PE07-057
FORD
2-4-2008
APPENDIX H1

Technical Service Bulletins-Active
07-10-10

2005-2007 F-Super Duty

This article supersedes TSB **07-5-7** to update the Parts.

Figure 1 - Article 07-10-10

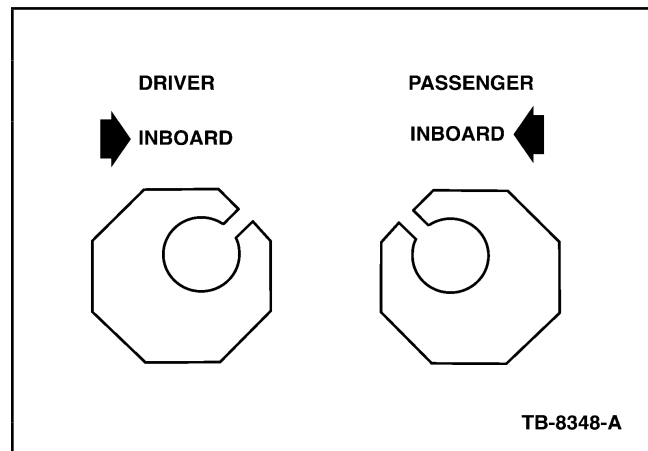
- Rotate the alignment adjustment bushing so that the bushing hole is in the 45 degree forward and inboard position. (See Figure 1)

- This should lower the caster, while keeping the camber within the specification range. If the camber is not in the specification range than rotate the alignment adjustment bushing as needed.
- The final caster and camber settings must be within the specification limits.
- Maintain the current front camber, cross-camber and cross-caster settings as close as you possibly can.
- Adding weight behind the rear axle lowers the rear of the vehicle, which decreases the frame angle, which in effect increases caster.
